2 Type of change

3 Detailed description of change

0909 Multiple IEC Appliance Outlets F							
Release date:	Released by:						
24.5.2011	SHÖ					1 von 2

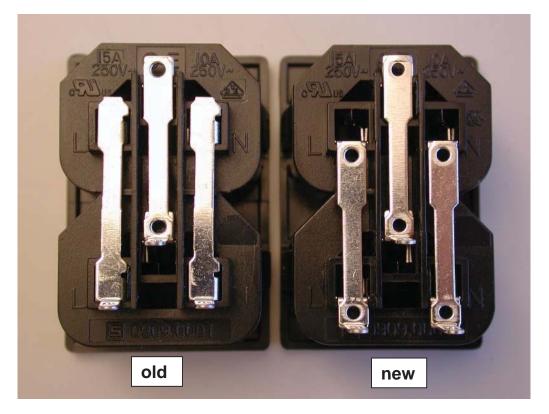
- L and N bars newly riveted to contacts, now are all 3 bars (L/N/E) riveted.
- Position of solder terminals of L&N are moved approx 5mm towards the border of the connector.

The old version had only the earth bar riveted to the outlet contacts - L/N bars and contacts were made of one piece. The new version has L/N/E riveted. (The holes are the riveting joints)

Position of solder terminals of L&N are moved approx 5mm towards the border of the connector.

Form:New internal joining technique, solder terminals of L&N are moved approx 5mm
towards the border of the connector.Fit:No influenceFunction:No influenceProduction Site:No influence
